Lancaster County School District Amendment #1	Solicitation Number	202502	
		Solicitation Issue Date	07/30/24	
		Amendment Issue Date	8/12/24	
		Procurement Officer	Trevor Hammond, NIGP-CPP, CPPB (803) 416-8828	
		E-Mail Address	trevor.hammond@lcsd.k12.sc.us

DESCRIPTION: **Restrooms for BHS & LHS Baseball Fields**

Effective this date, this amendment forms part of the contract documents and modifies the original IFB

B4 LEFT-SIDE ELEVATION
1/4" = 1'-0"

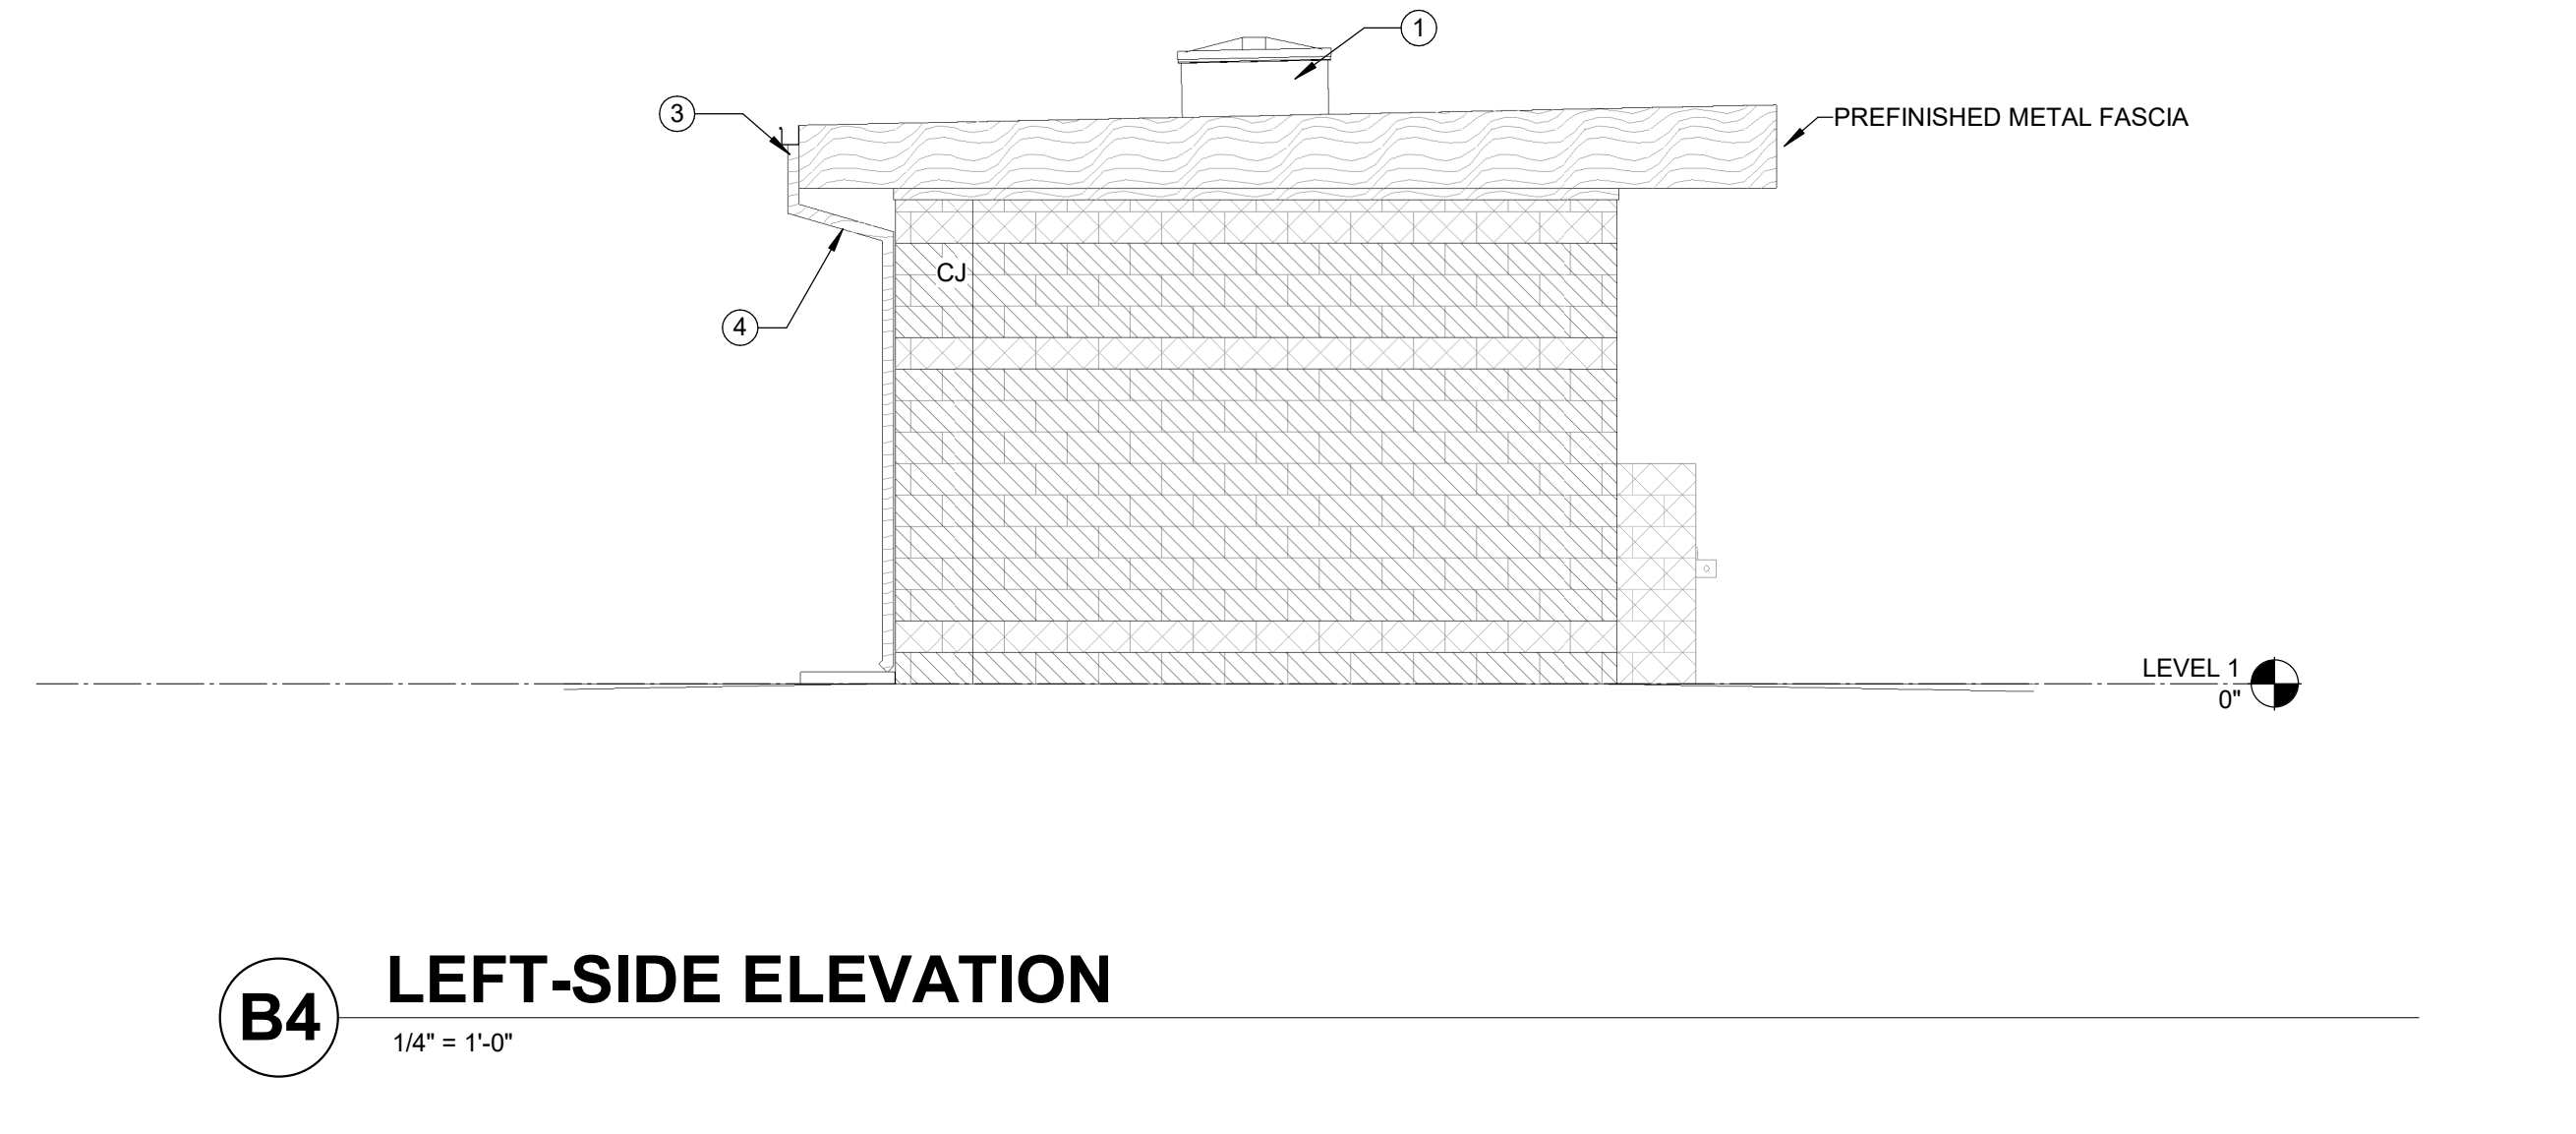
- F. Replace Sheet A-201 with revised sheet A-201 – Exterior Elevations, included in the Attachments.
 - 1. Elevations, legend and schedule were revised to remove exterior block that was to be painted in lieu of colored smooth and split face CMU.
